AMENDED ARRANGEMENT OF DECK PLATING

PLAN NO 32.
DRAWN BY J.W.T.
CHECKED BY

W. GRAY & CO. LIMITED
21. 3. 28
WEST HARTLEPOOL

8 City of Dieppe
W. H. Pl. rep. 16775

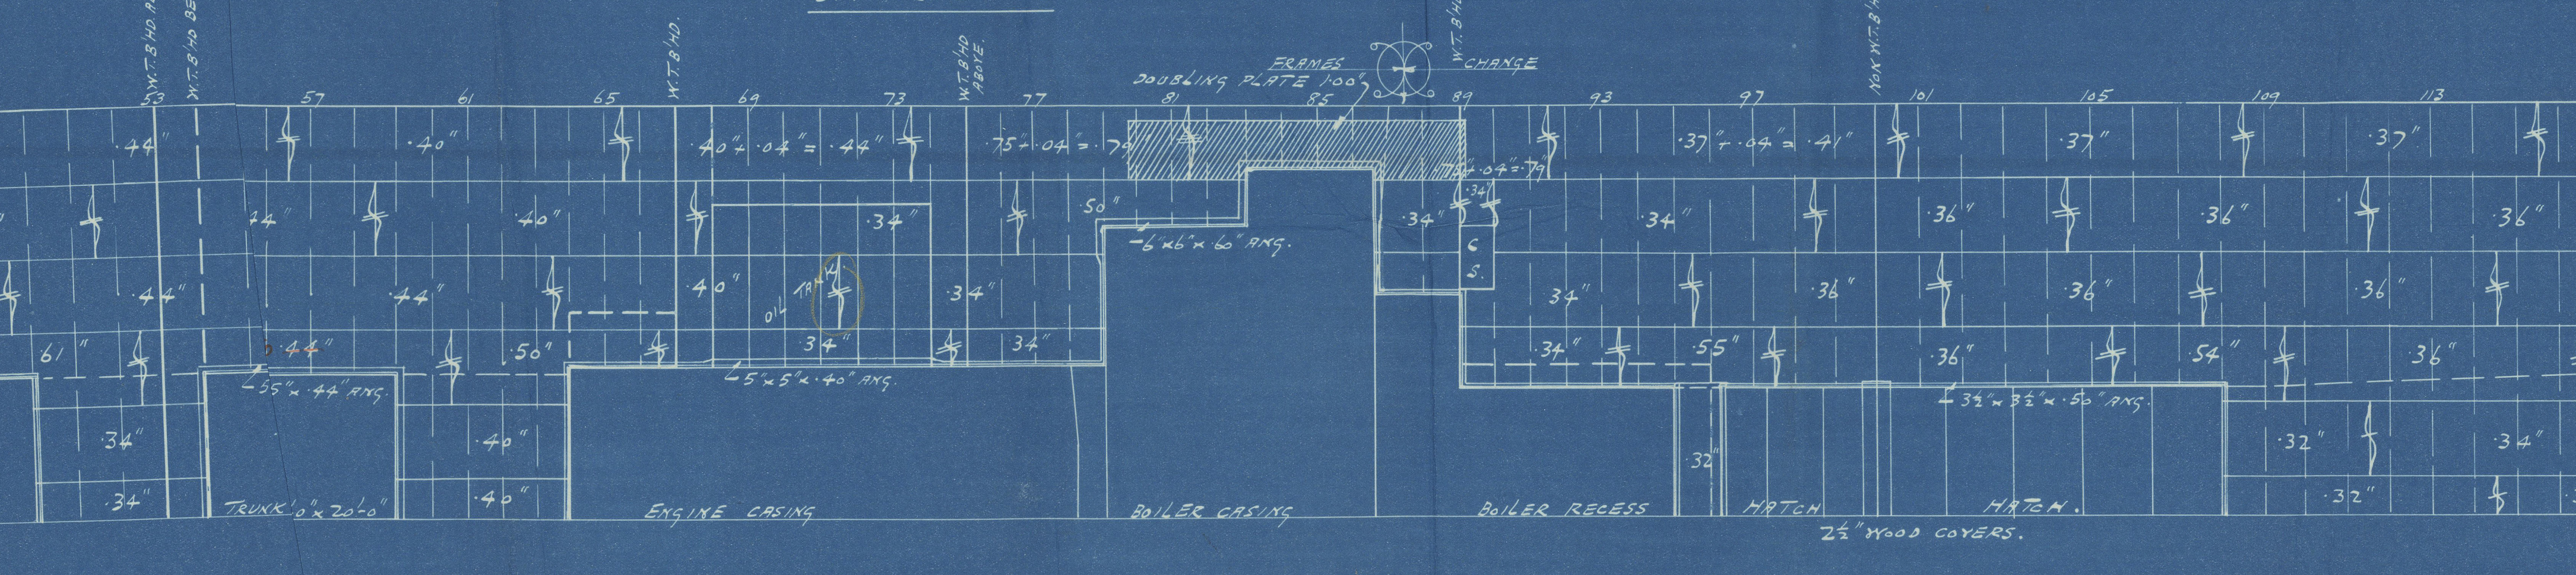
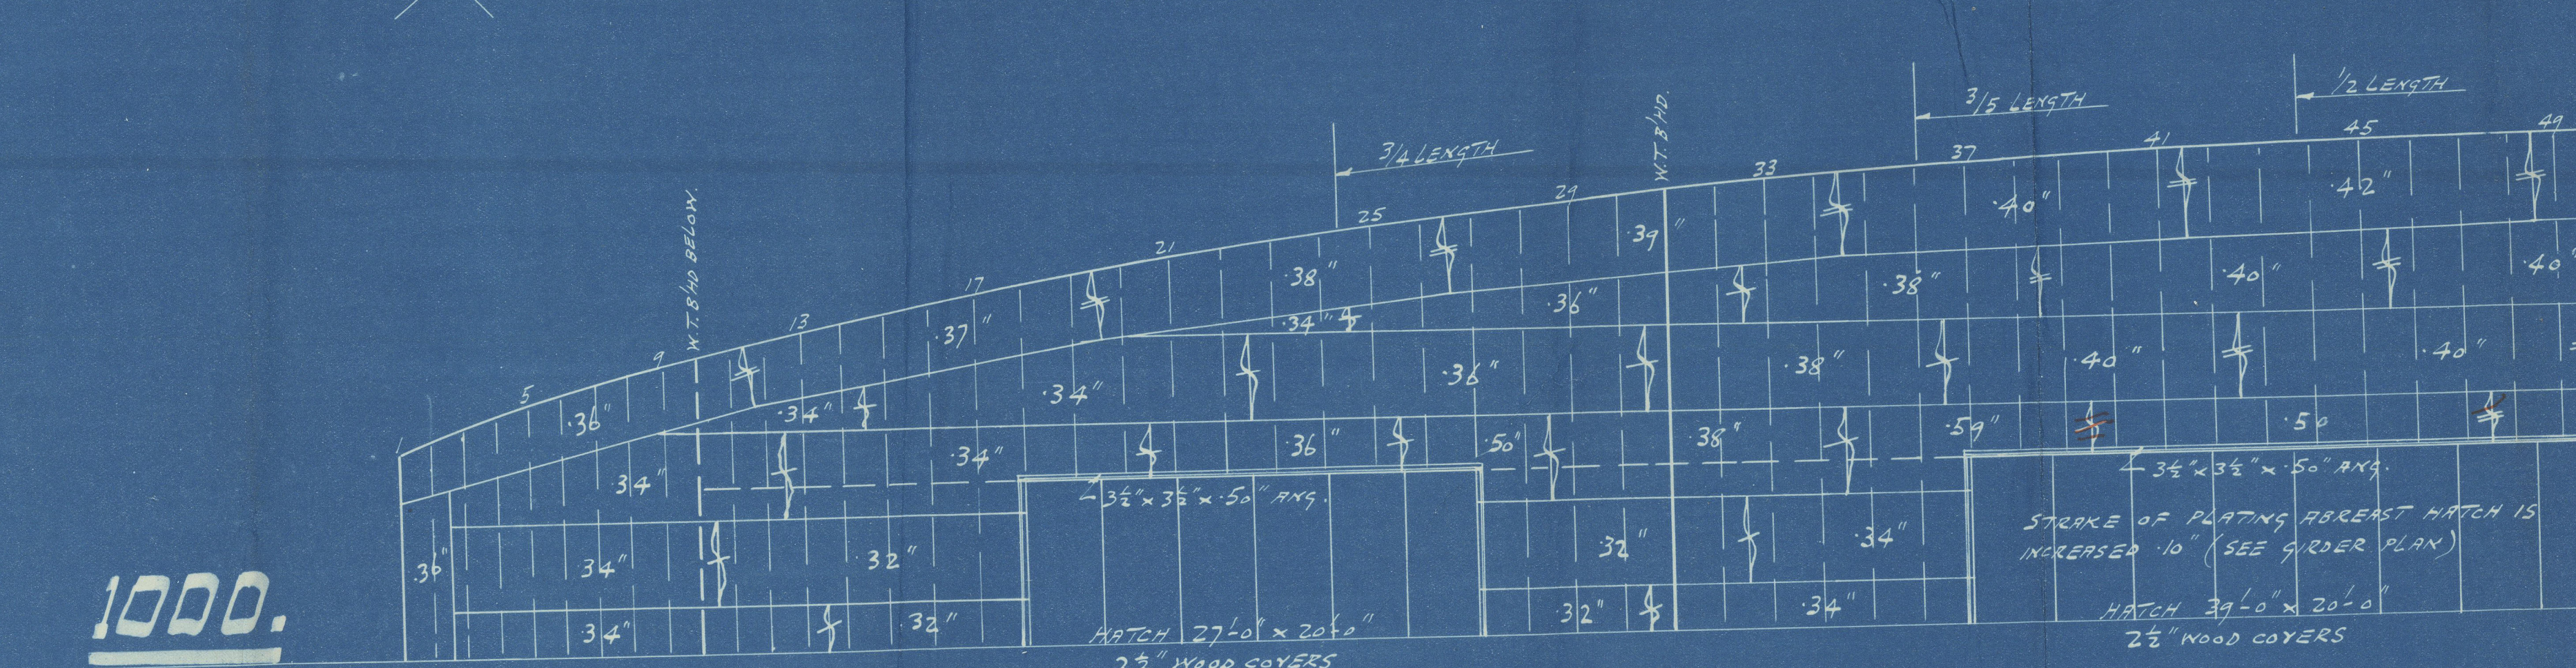
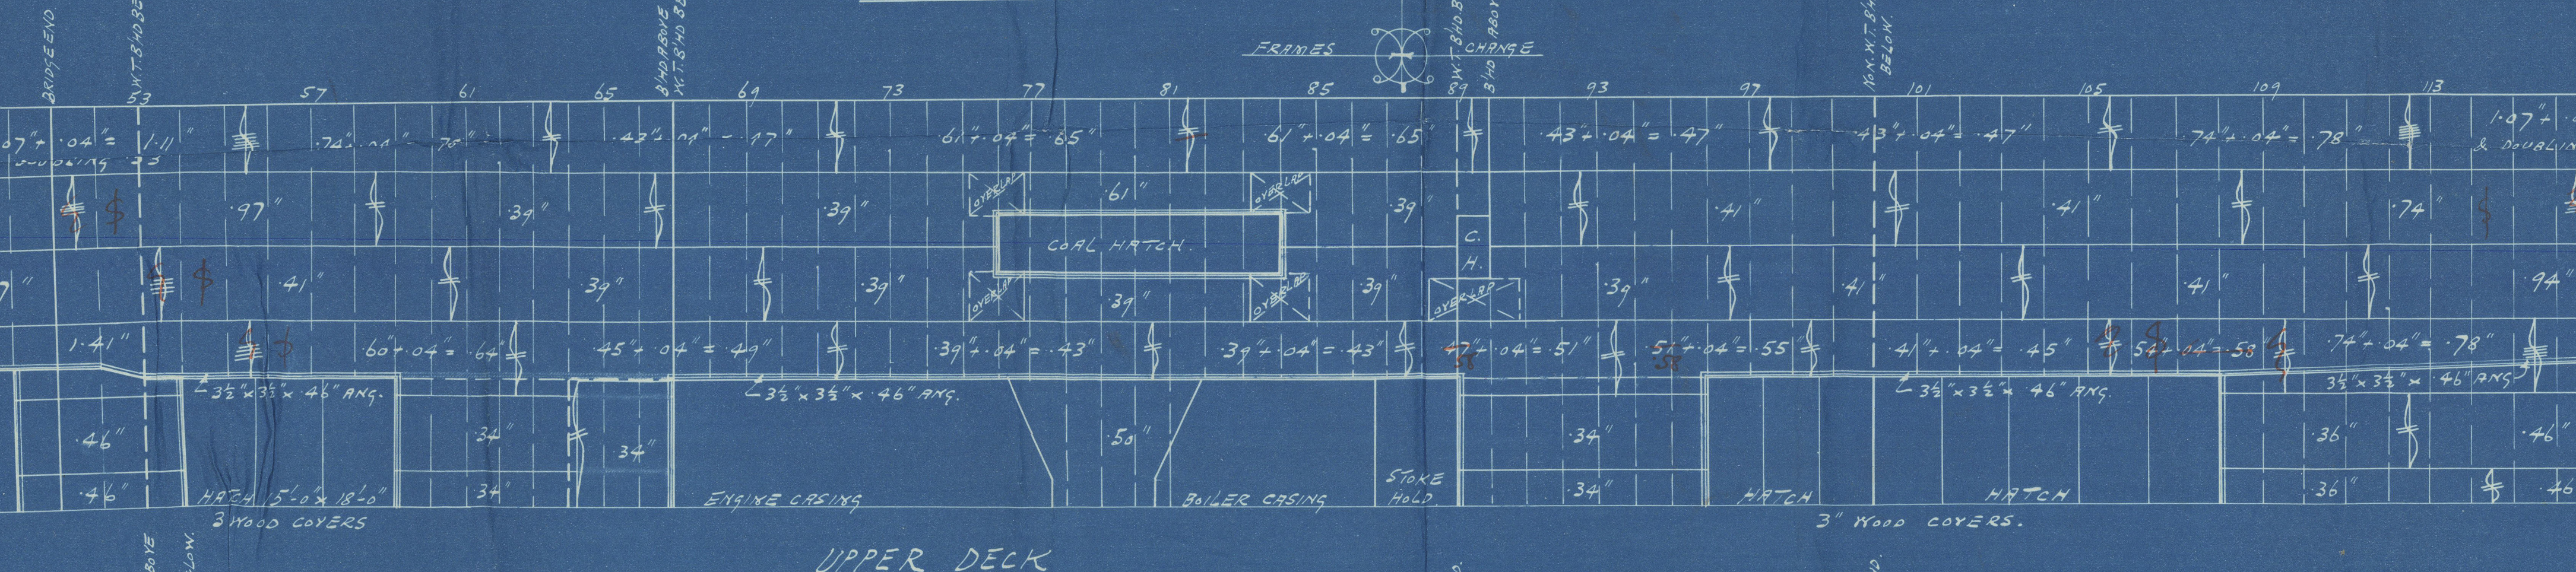
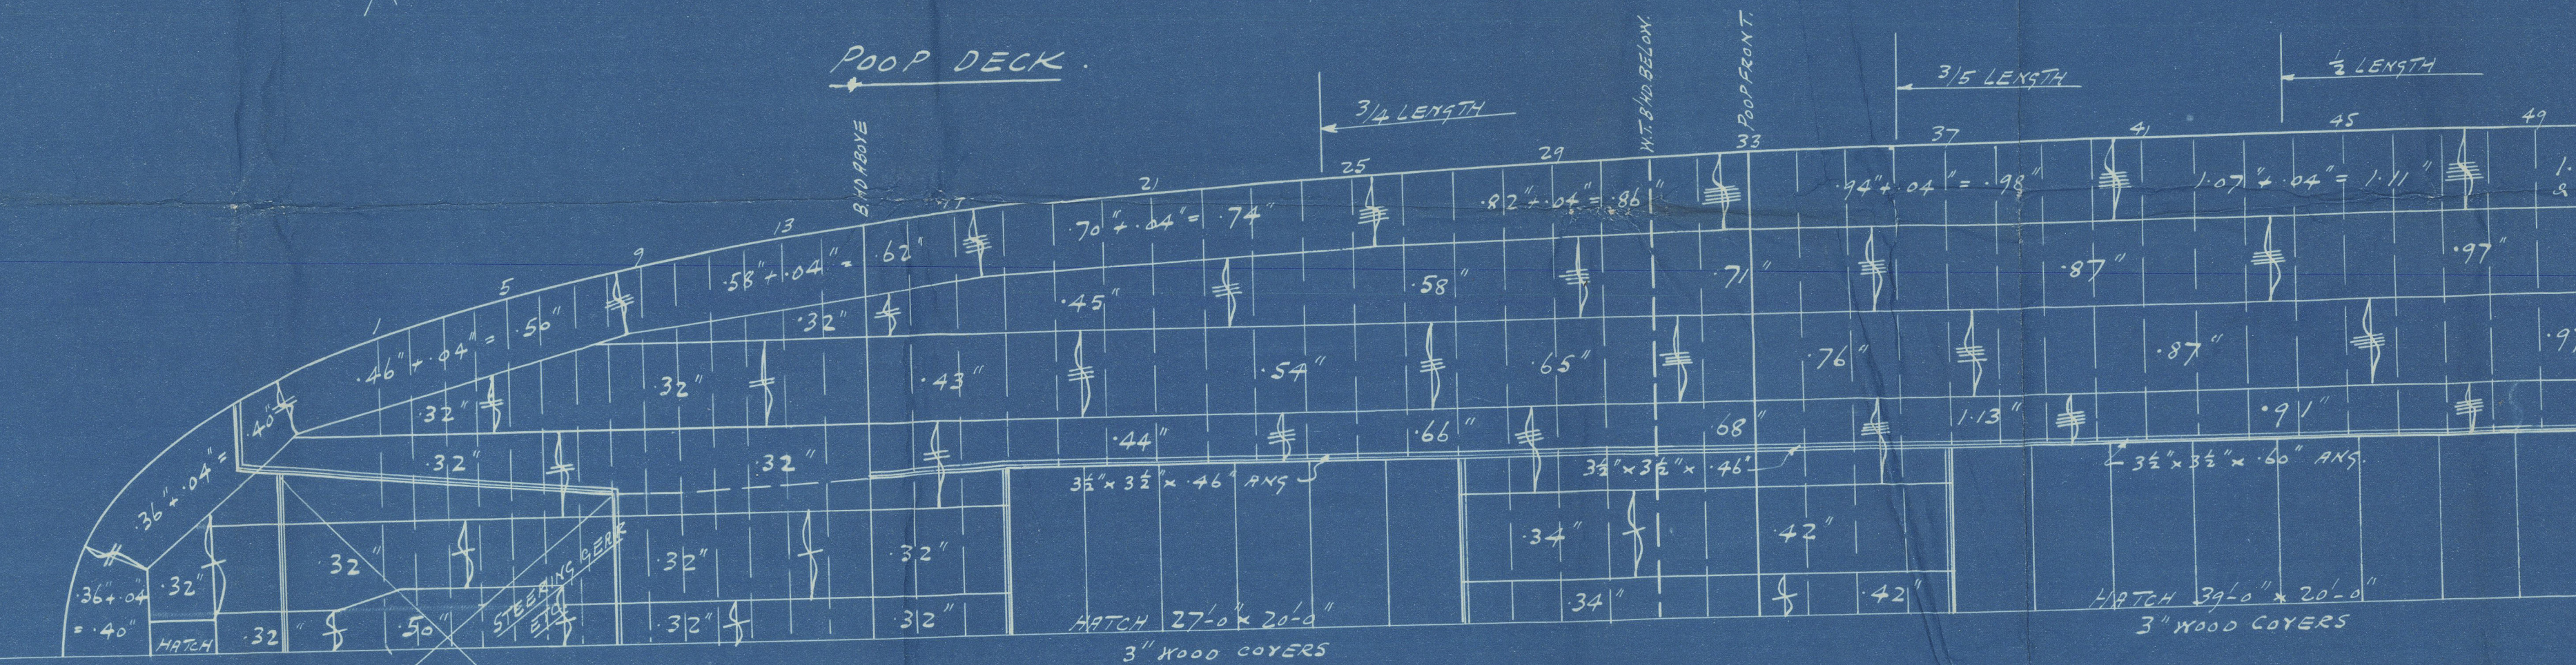
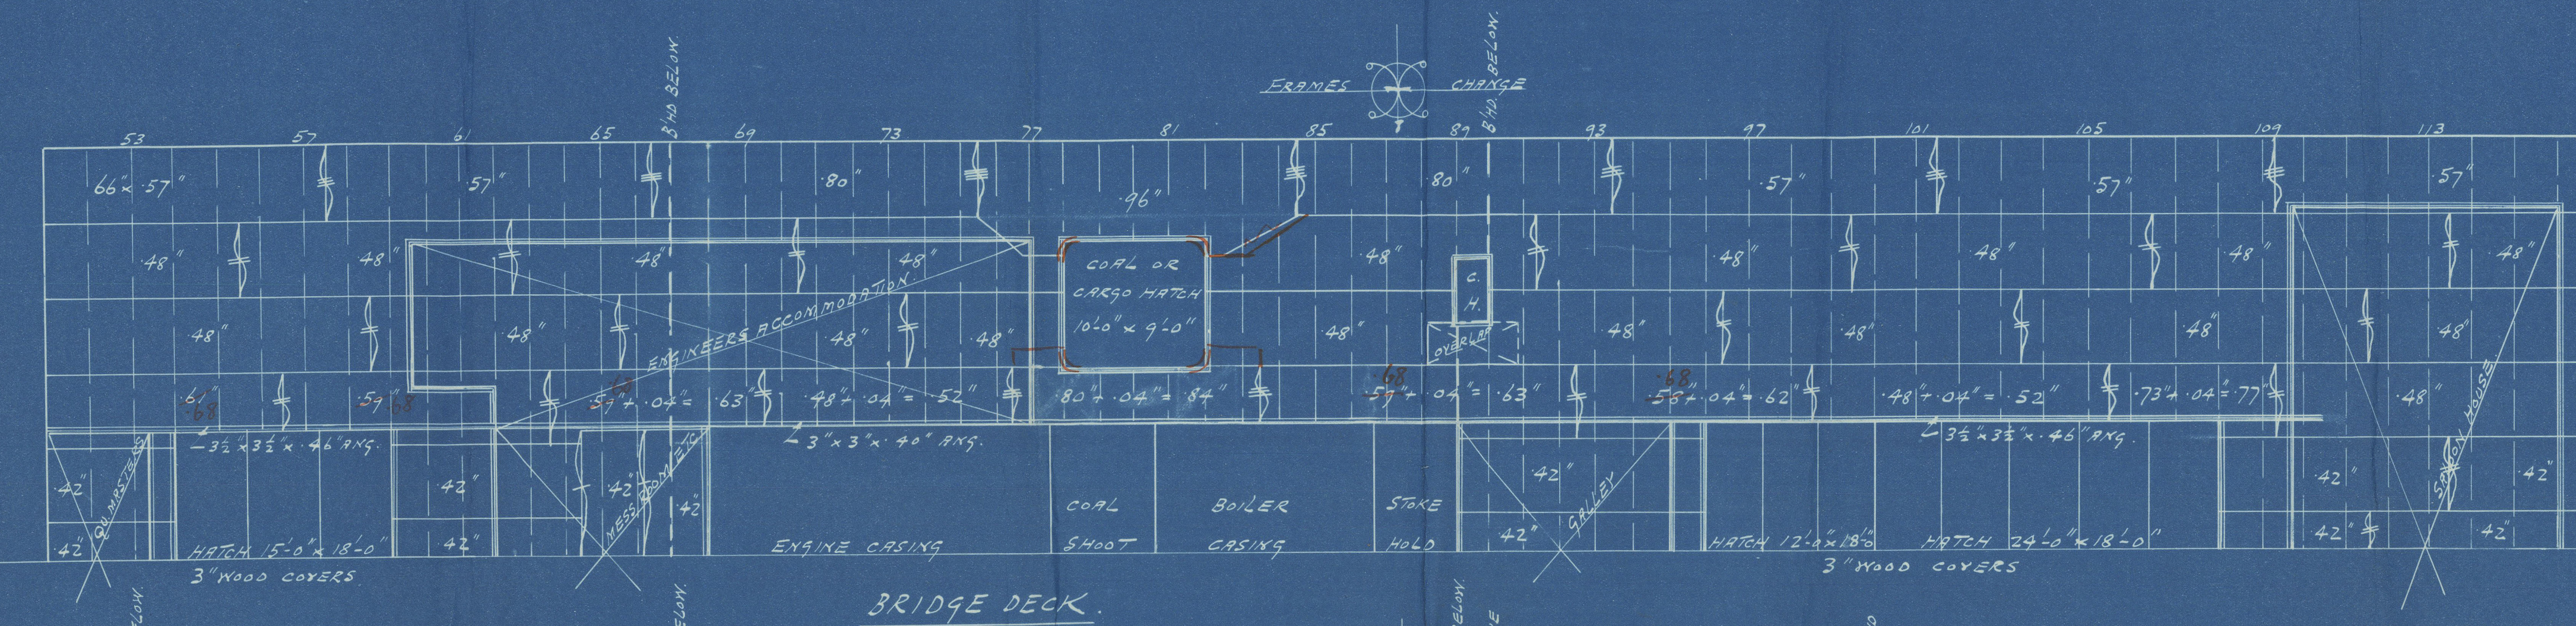
NOTE - DECK PLATING INCREASED AT HATCH CORNERS & CORNERS OF LARGE DECK OPENINGS IN LIEU OF FITTING DOUBLINGS.
